SUNDRY NOTICES AND REPORTS ON WELLS (DO NOT USE THIS FORM FOR PROPOSALS TO DRILL OR TO DEEPEN OR PLUG BACK TO A DIFFERENT RESERVOIR. USE "APPLICATION FOR PERMIT" (FORM C-101) FOR SUCH PROPOSALS.) 1. Type of Well: Oil Well <input checked="" type="checkbox"/> Gas Well <input type="checkbox"/> Other <input type="checkbox"/>		WELL API NO. 30-005-20007

Cano Petro Of New Mexico
Cato San Andres #100
API: 30-005-20007
Chaves County, New Mexico

Plug And Abandonment Procedure

Cato San Andres #100

Proposed Wellbore Diagram

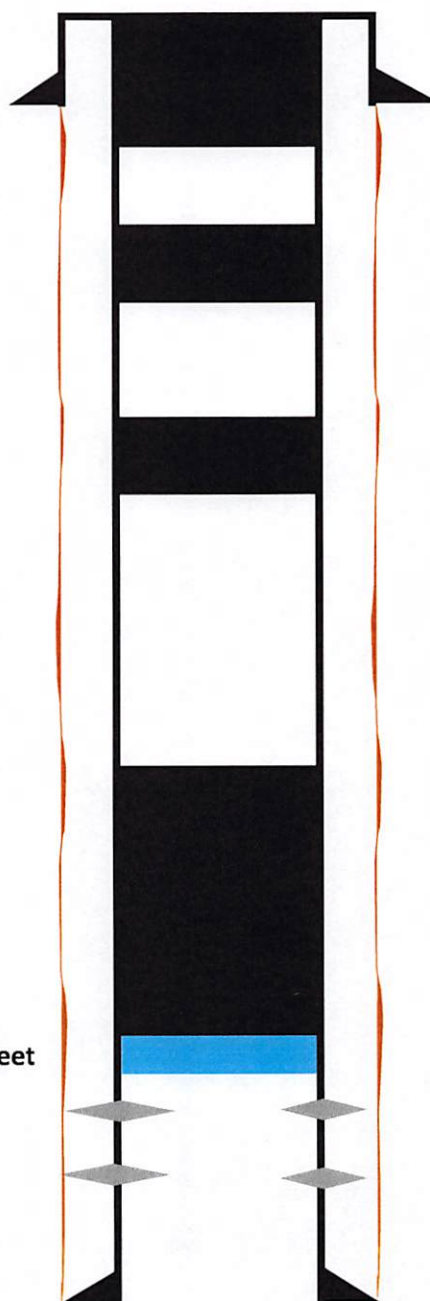
APPROVED WITH CONDITIONS

Perf & Sqz all
 plugs where no
 cmt behind pipe.

Perf & Sqz all csg
 shoes.

Adhere to NMOCD
 COAs attached.
